PROJECT NARRATIVE

FILE NO. #30-86 TITLE HEADING Conditional Use for Church in RSF-4 DUE DATE 10-16-86

ACTIVITY - PETITIONER - LOCATION - PHASE - ACRES Conditional Use for a Church in RSF-4,
SW corner of Northacres Road & 26 1/2 Road, Bookcliff Church of Christ, Ken Brodel

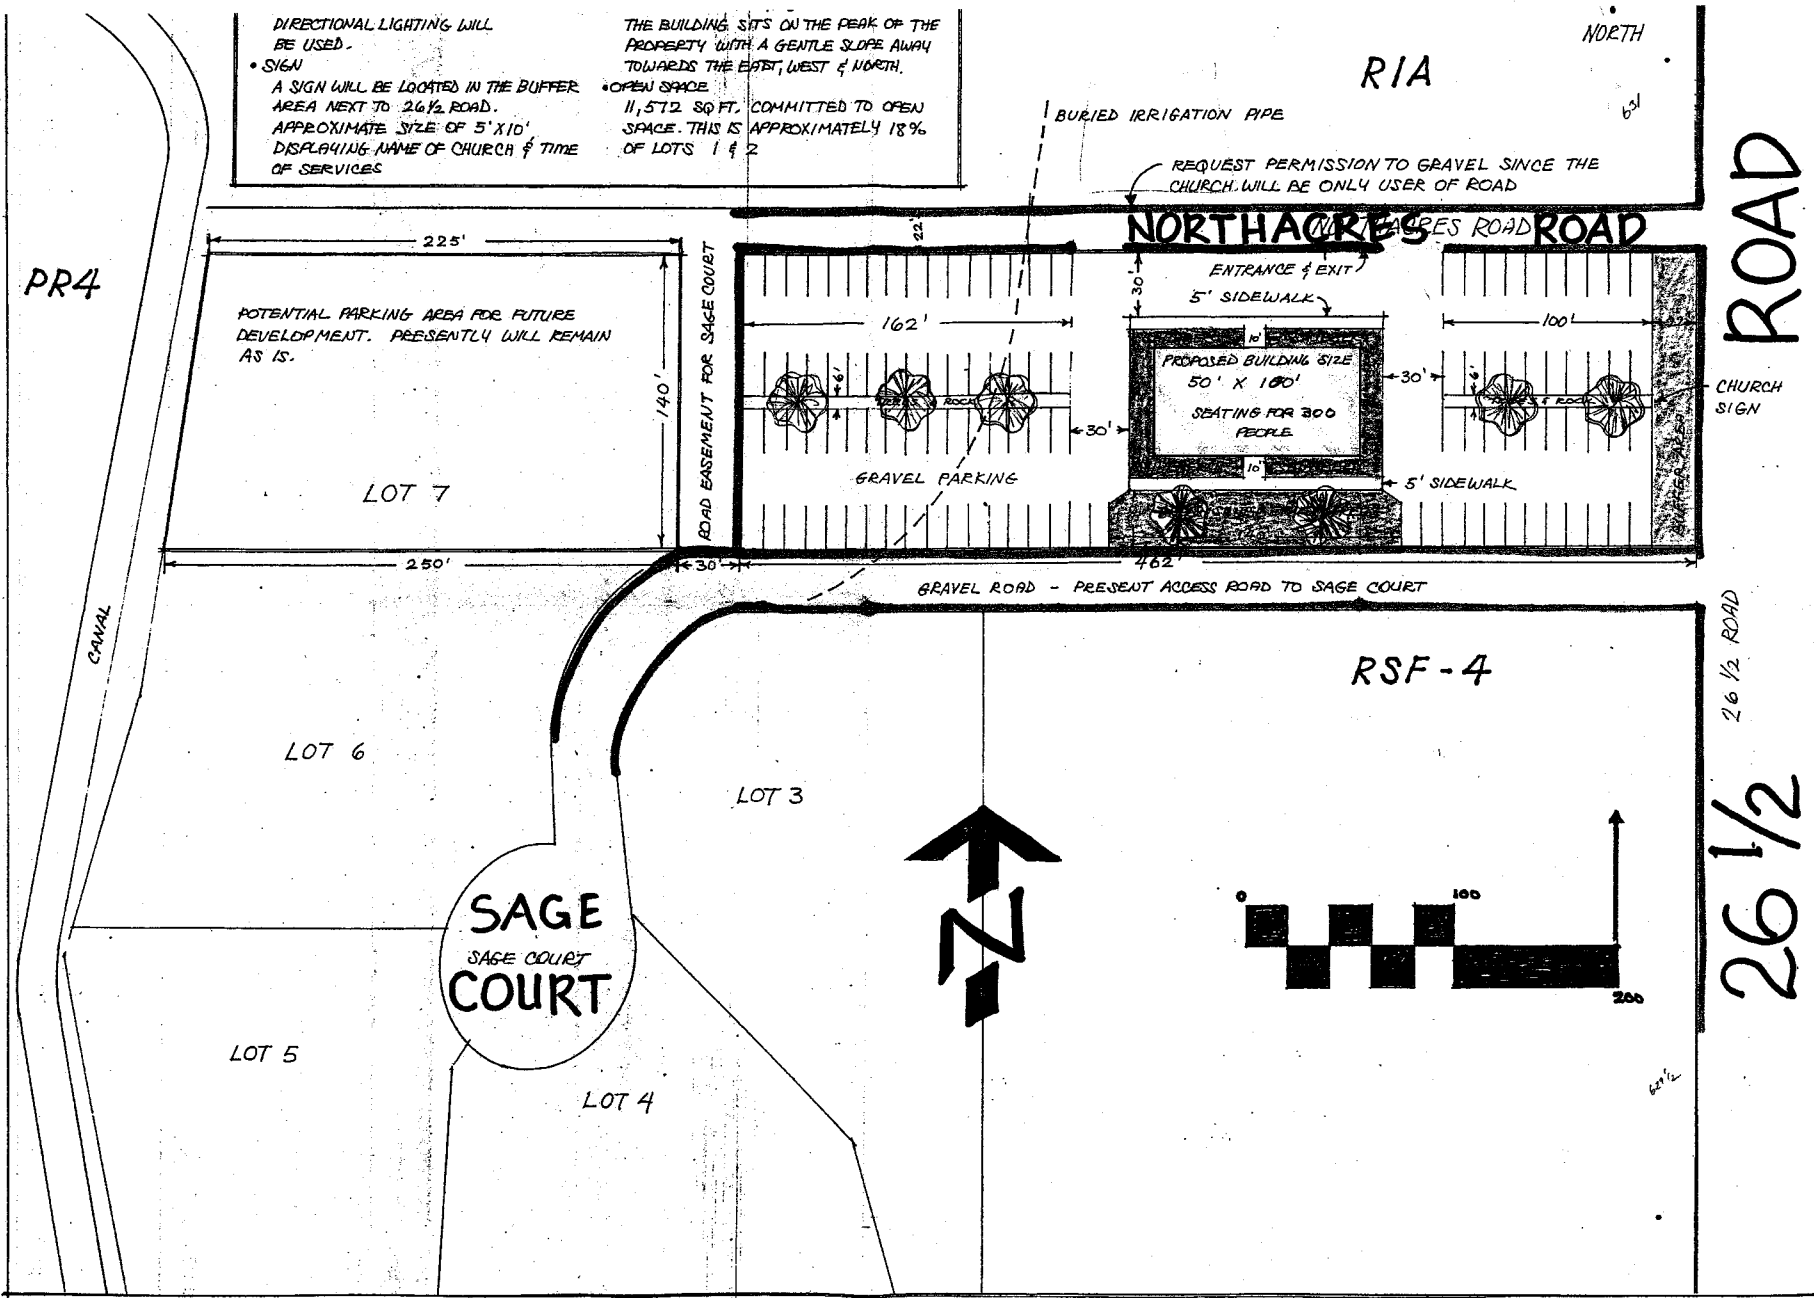
Staff has requested that due to the close proximity of the proposed parking lots and street to an existing residence, the lots and street should be paved. The petitioner disagrees on the grounds that the site will only be used on 3 occasions per week & therefore the requirement will cause undue expense.

Staff has no opposition to approval but has a ^{of opinion} consensus that the street should be improved at the time of Church development. If not, there is little chance the street will ever be constructed without a forced improvements district.

Planning Commission Action Approval of the Conditional use providing that full street improvements (except sidewalk) be completed for 1/2 the length of the Church property; that the parking lots be constructed with a dust-free surface (not necessarily asphalt paving); and that the petitioners appear before Planning Commission at the time final development plans are complete and they are ready to commence w/ construction.

With regards to paving parking lots; in view of the following reasons the petitioner feels that a gravel parking lot should be adequate.

1. The property is not going to be used on a daily basis. It will be used only three times a week: Sunday morning, Sunday evening, and Wednesday evening.
2. It is the petitioner's understanding that city code does not specify pavement as an absolute and that a gravel parking lot can meet city code for dust control. Therefore, in view of the minimal usage of the facility additional ground coverage should not be required.

4. At present costs an additional \$40,000 would be needed if paving were required. In view of the prior reasons stated it is believed that paving would require the petitioner to bear an unreasonable initial cost.

With regards to Northacres Road; in view of the following reasons the petitioner feels that something less than full road improvements be allowed.

1. Northacres Road will be used only by petitioner. It accesses no other residences. And it will be used on only three occasions a week.
2. Considering that the future extension of Northacres Road across the canal is dubious (in view of easier access to Horizon Court for Northridge at a lesser expense) it appears unreasonable to make such stringent requirements for a road that very likely may never exceed the proposed use by the petitioner.
